March 20, 2018
15045

Third Party Review of the Rezoning Petition in Northern Aroostook County, Fish River Chain of Lakes Concept Plan

SLOPE EVALUATION OF FISH RIVER CHAIN OF LAKES DEVELOPMENT AREAS

LOCATION: LONG LAKE B	FOR: J.D. IRVING LIMITED	INFORMATION: 2011 LIDAR DERIVED DATA PROVIDED BY J.D. IRVING, LIMITED
--------------------------	-----------------------------	--

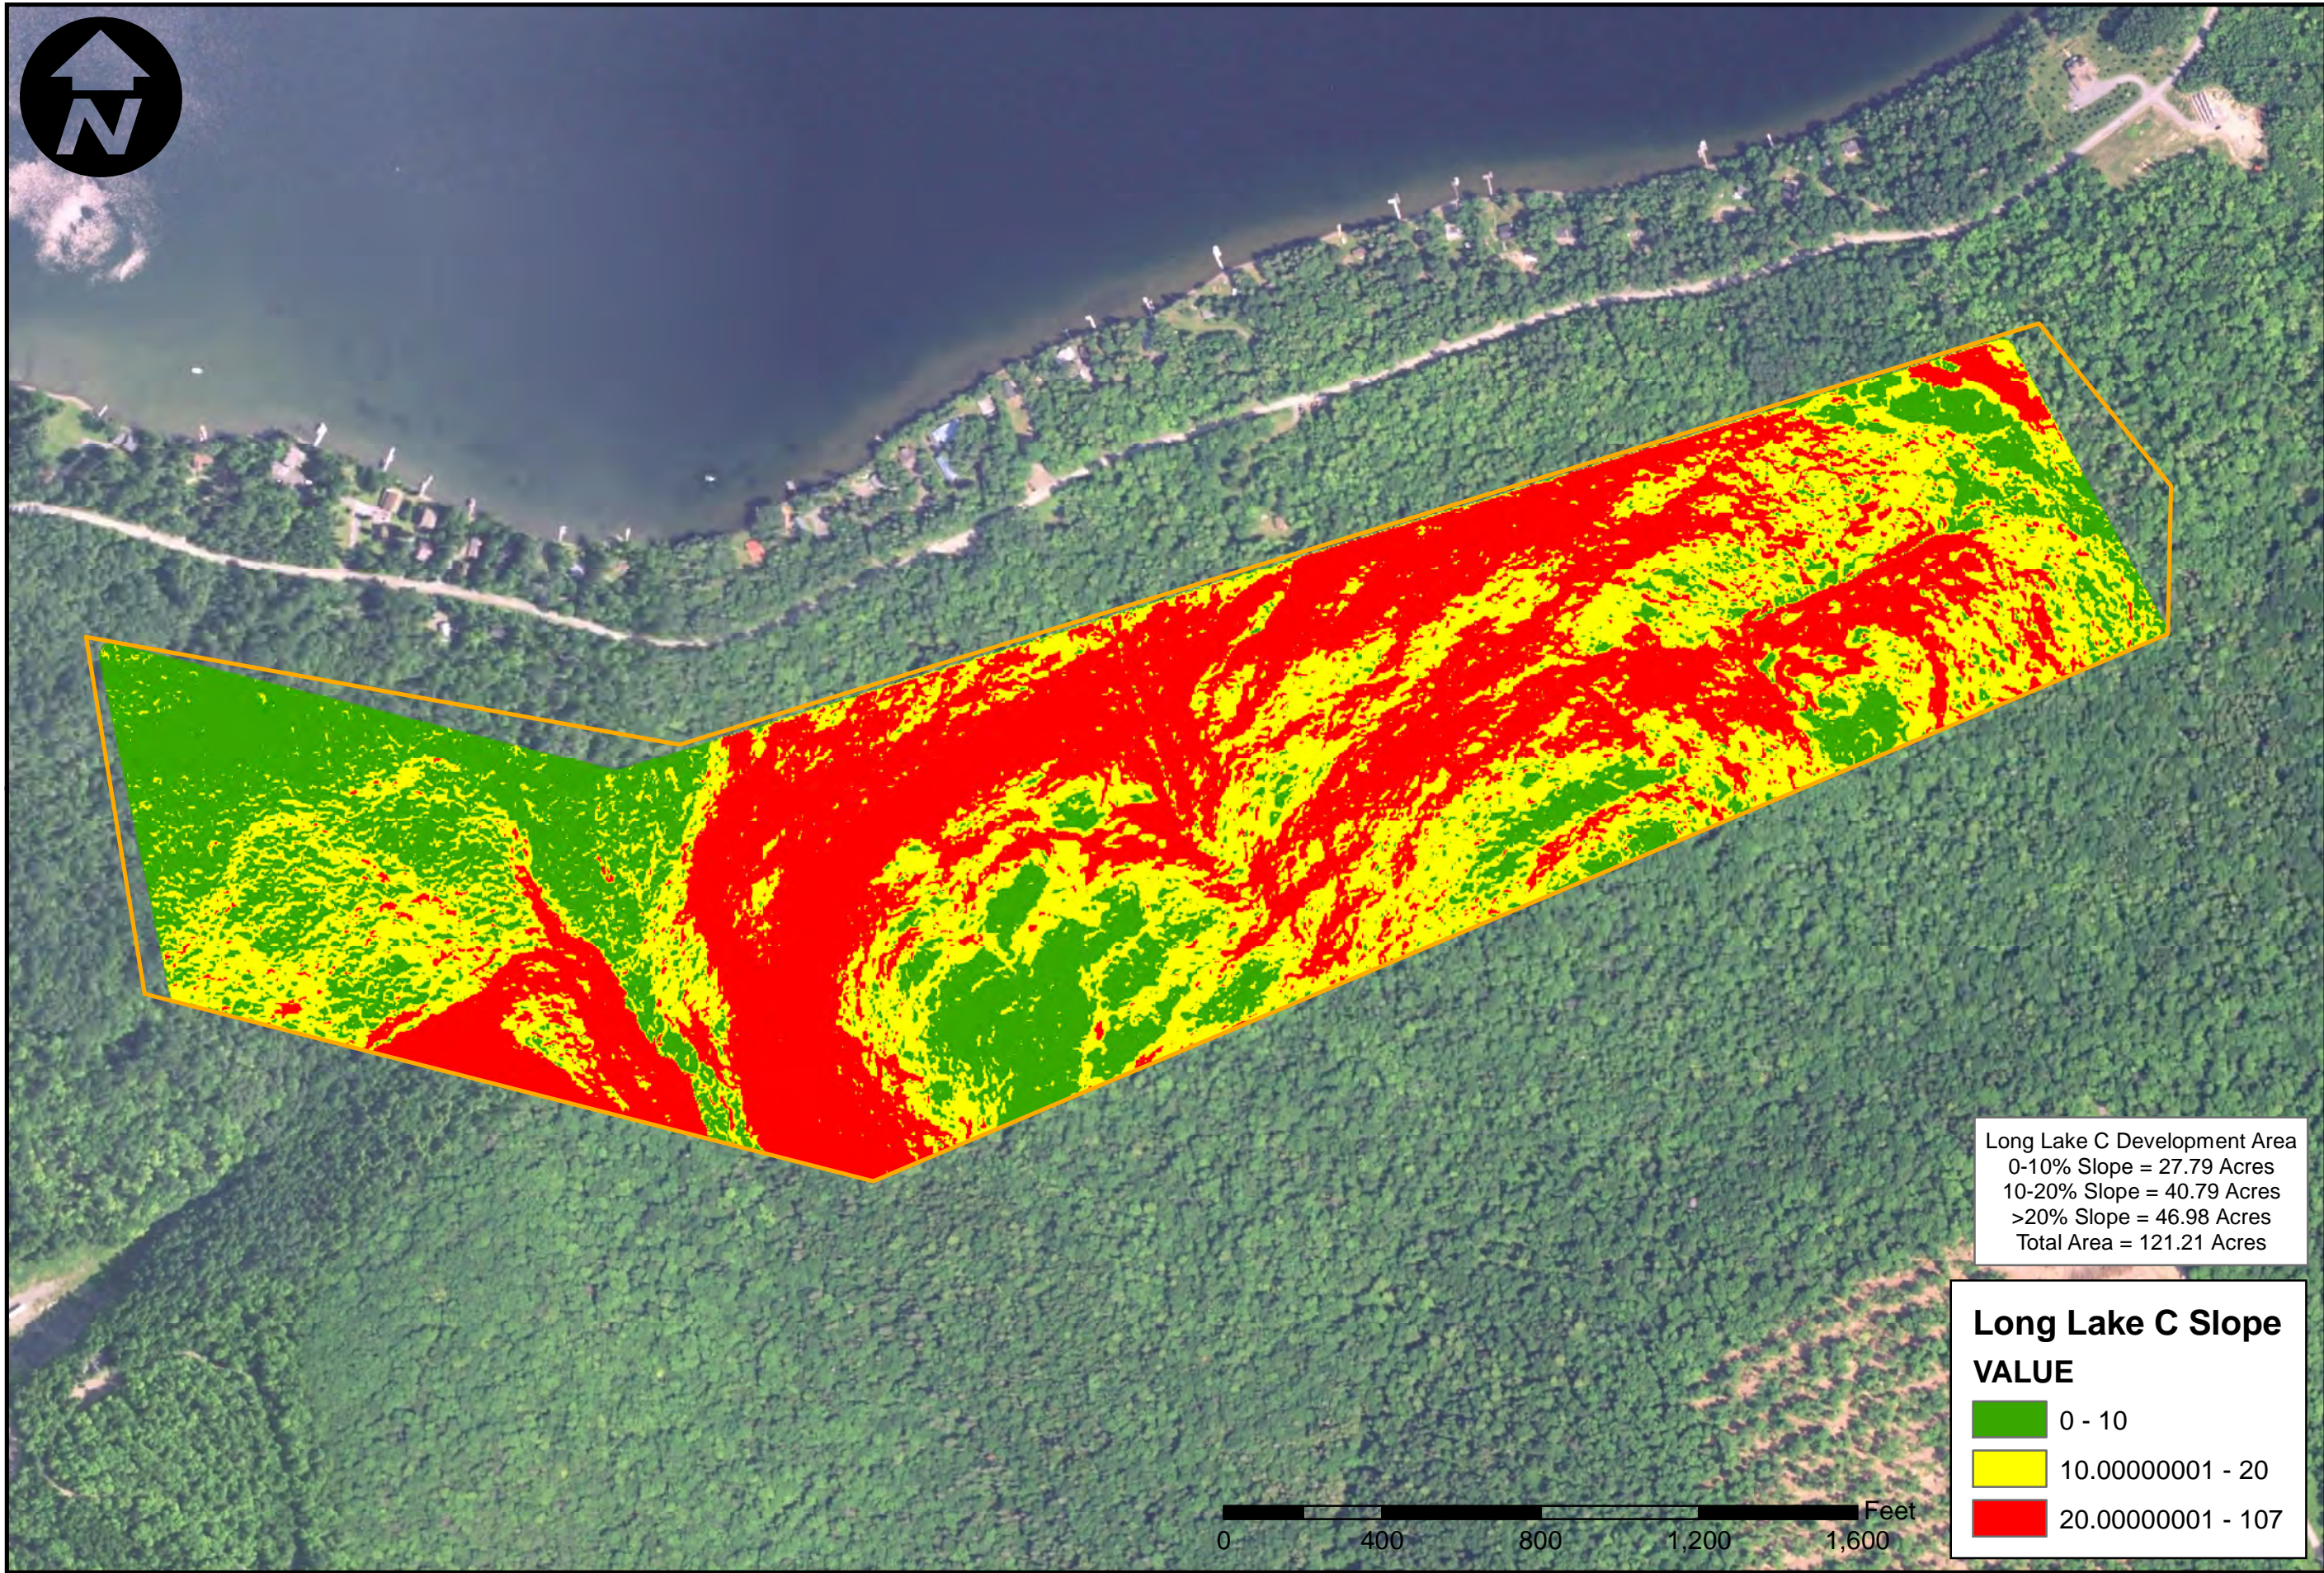
1. **Slope Analysis:** The slope analysis indicates approximately 11 acres of the development area contains slopes greater than 20 percent and are considered unsuitable for development. The greater than 20% slopes are generally associated with linear slope. Slopes 0-10% slopes encompass approximately 17 acres. Limited suitability slopes (10 to 20% slopes) encompass approximately 27 acres of the project area. The slope assessments suggest the development area is partially suitable for the intended purposes noting that the slopes greater than 20% are not considered suitable for development due to limitations for wastewater disposal systems, erosion and drainage control considerations and slope stability.

The LiDAR terrain mapping suggests a linear feature of slopes in excess of 20% runs parallel to the primary access road between the existing camps and proposed development area. This will present a physical barrier impacting the ability to access the westerly portion of the property. As a result, access to some of the developable land may be difficult or not practicable due to physical constraints. Therefore, while the net developable area of 2.1 acres/unit appears reasonable, we recommend further evaluation and confirmation that the westerly land area can be reasonably accessed.

2. The soils in this development area (NRCS Mapping) include HoB/HoC (Howland gravelly loam) and ThD (Thorndike channery silt loam) soil series. The ThD soils are considered unsuitable due to steep slopes and expected susceptibility to erosion when disturbed. ThD soils are also shallow to bedrock which serves as a restrictive layer at 11 to 23 inches. The soils in this project area range from a gravelly loam to a silt-loam and are moderately well to somewhat excessively drained with a water table over 16 inches and considered a hydrologic group "C/D" and "D" soils. These soils present some limitation depending on slope and location of the restrictive layer along with higher erosion potential and stormwater management considerations.

Our assessment suggests that the project area and number of planned units (15) yields an effective net density of 2.1 acres/unit (*Please refer to the development matrix analysis appended to this report*). This assessment includes deductions for slopes over 20% and allowing for 25% of the 10% to 20% (limited suitability slopes) to be considered not suitable.

While this net density appears reasonable, the physical location of the mapped feature represents potential restrictions in accessing the development land and will require special attention to the management stormwater to meet Maine DEP chapter 500 regulations. Additionally, the northerly area of the project site appears to be nearly all slopes in excess of 20% and therefore not suitable for development.

In conclusion, we recommend further consideration of this development parcel as it pertains to accessing the developable areas through the steep slope areas and the developability of the northerly portion of the site since this area appears to be generally consumed by slopes in excess of 20%.

Long Lake C Development Area
 0-10% Slope = 27.79 Acres
 10-20% Slope = 40.79 Acres
 >20% Slope = 46.98 Acres
 Total Area = 121.21 Acres

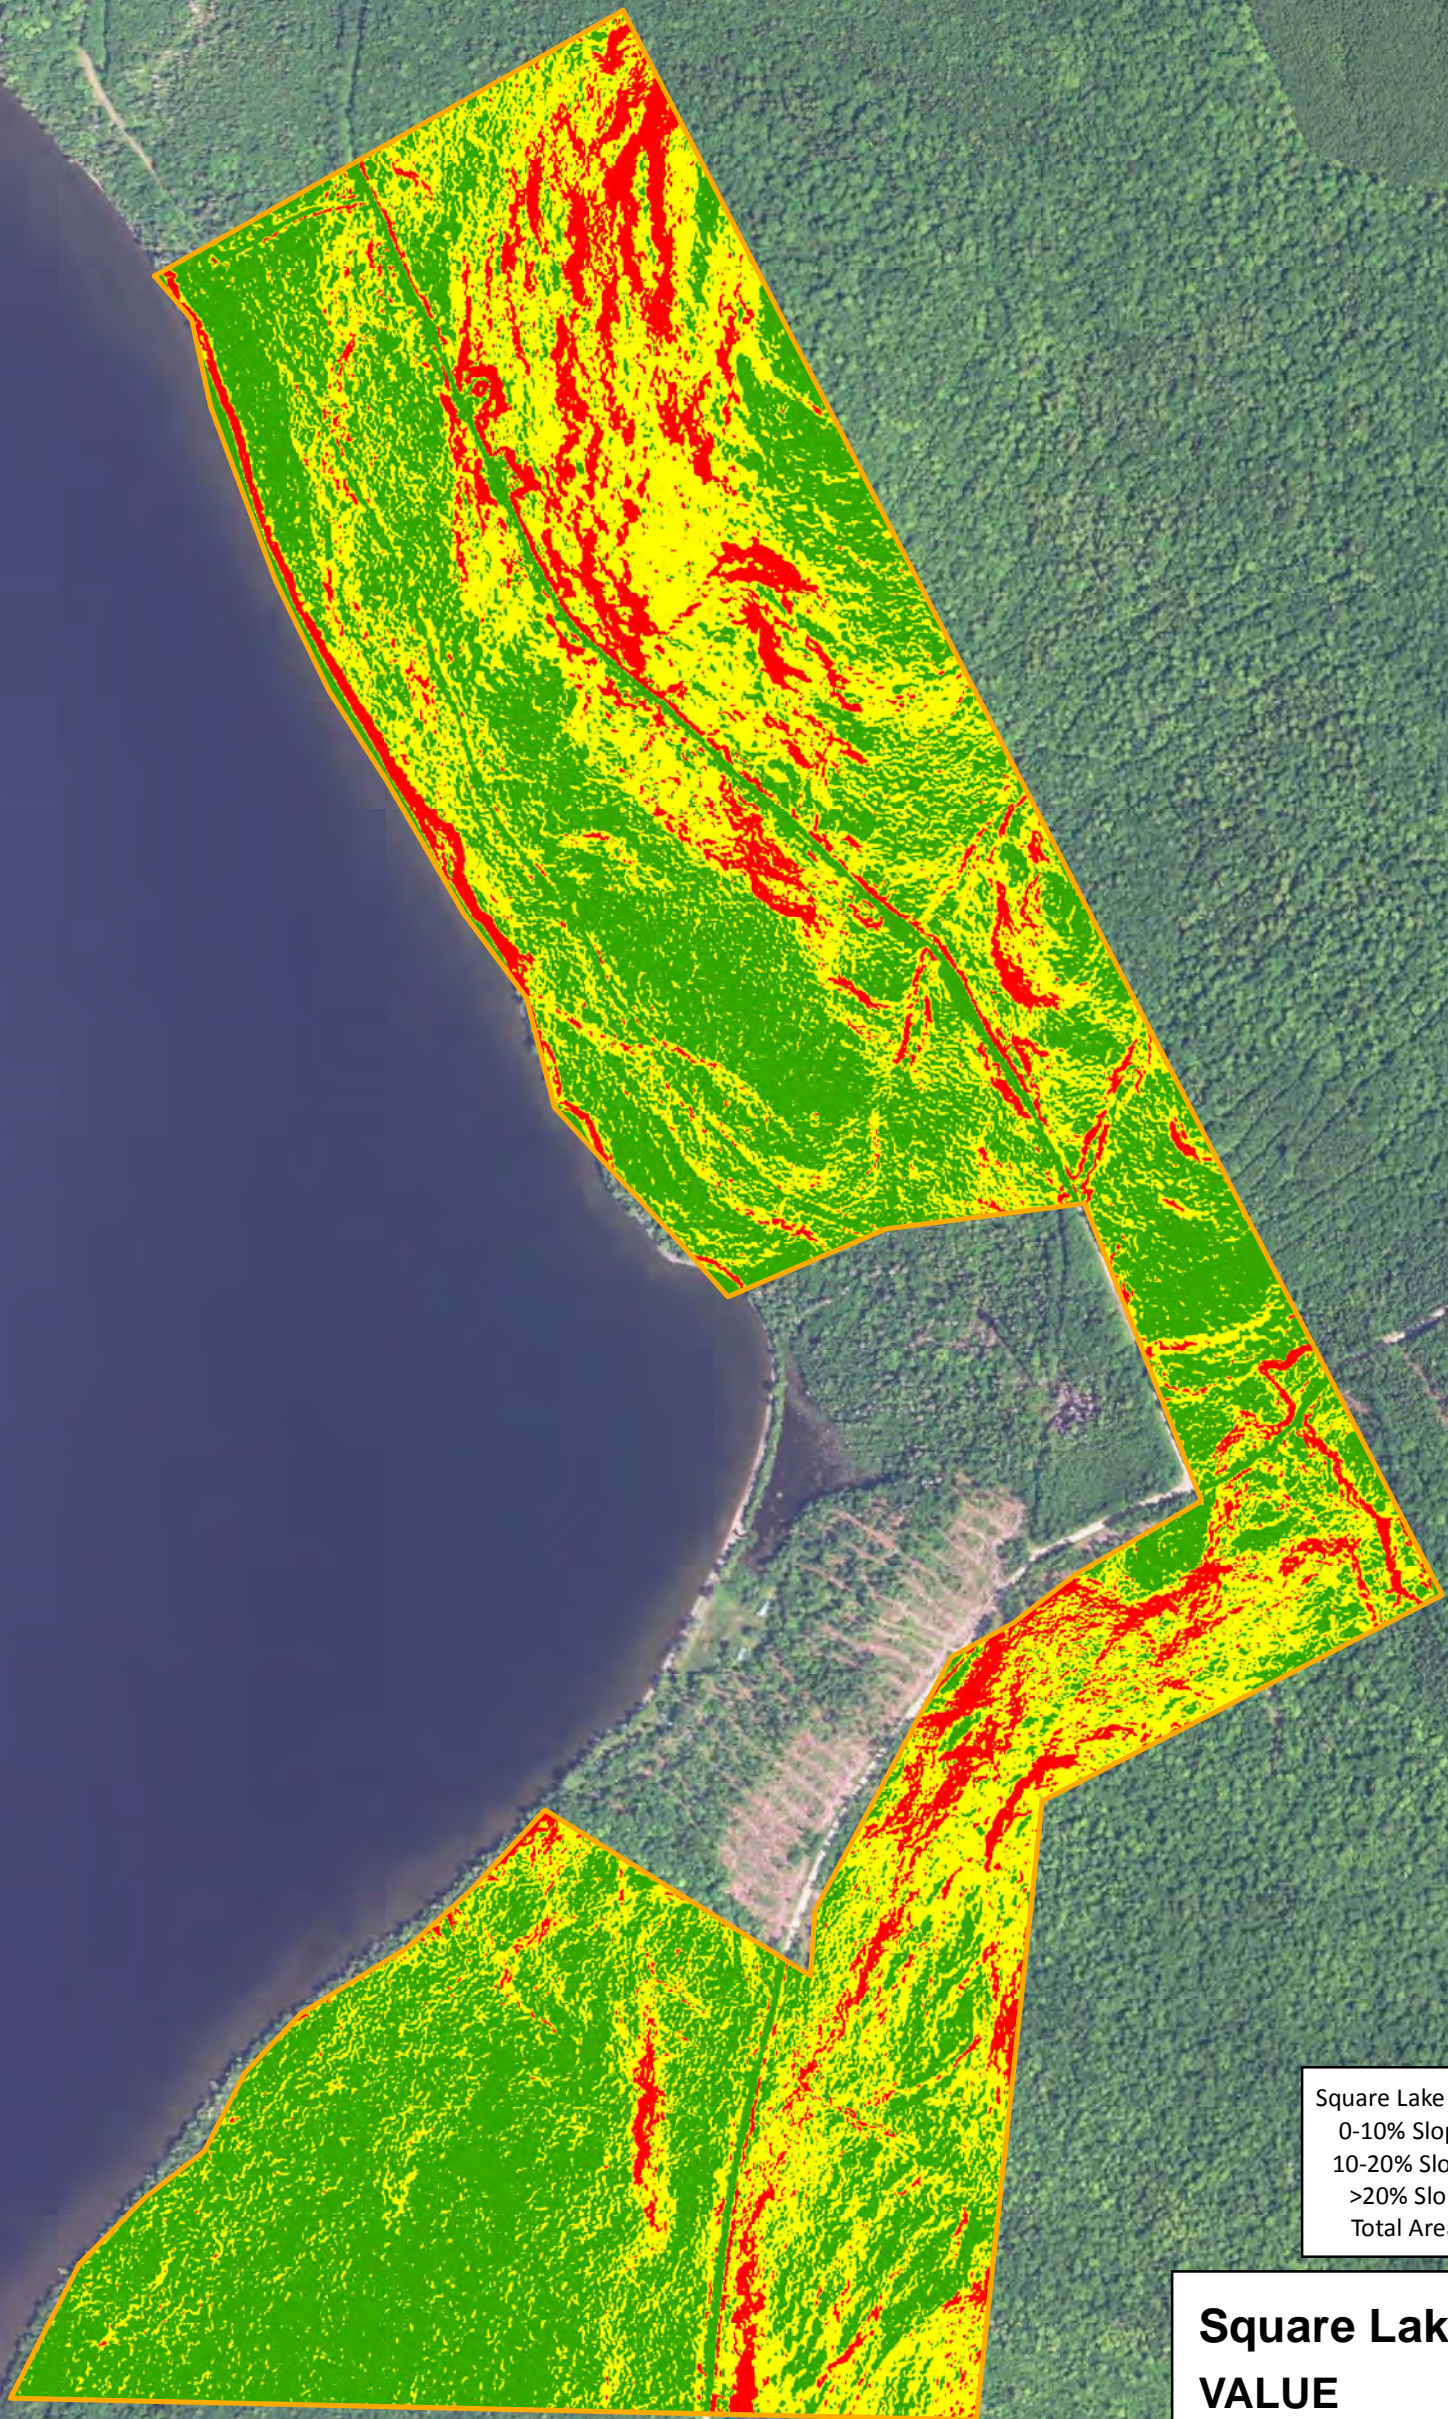
1. **Slope Analysis:** The slope analysis indicates approximately 47 acres of the development area contain slopes greater than 20 percent and generally considered unsuitable for development. The greater than 20% slopes appreciable and likely associated liner slope features. Slopes of 0-10% encompass approximately 28 acres. Limited suitability slopes (10 to 20% slopes) encompass approximately 41 acres of the project area. The slope assessment suggests the development area is suitable for the intended purposes noting that extensive slopes greater than 20% that are not considered suitable for development due to limitations for wastewater disposal systems, erosion and drainage control considerations and slope stability. These areas are will restrict the locations for development, access and require careful planning to accommodate the slopes.

2. The soils in this development area (NRCS Mapping) include HcV (Howland silt-loam), ThC (Thorndike channery silt loam) and PgB/PgC/PgD (Plaisted gravelly loam) soil series. A small area of MoB is located in the westerly corner of the site. These soils range from a gravelly loam to a silt-loam and are well, moderately, somewhat excessively drained with a water table over 17 inches and considered a hydrologic group "C" and "C/D" soils. The ThC soils are generally shallow to bedrock which serves as a restrictive layer at 11 to 23 inches. Theses soils present some limitations depending on slope and location of the restrictive layer along with higher erosion potential for the surficial soils and potential difficulties addressing stormwater management.

Considering the soil types and associated development limitations including slopes over 20%, our assessment suggests that the project area and number of planned units (25) yields an effective net density of 2.0 acres/unit. This represents a reasonable and appropriate net development density (*Please refer to the development matrix analysis appended to this report*) noting that the steep slopes will restrict development from several areas of the project area. This assessment includes deductions for slopes over 20% and allowing for 25% of the 10% to 20% (limited suitability slopes) to be considered not suitable.
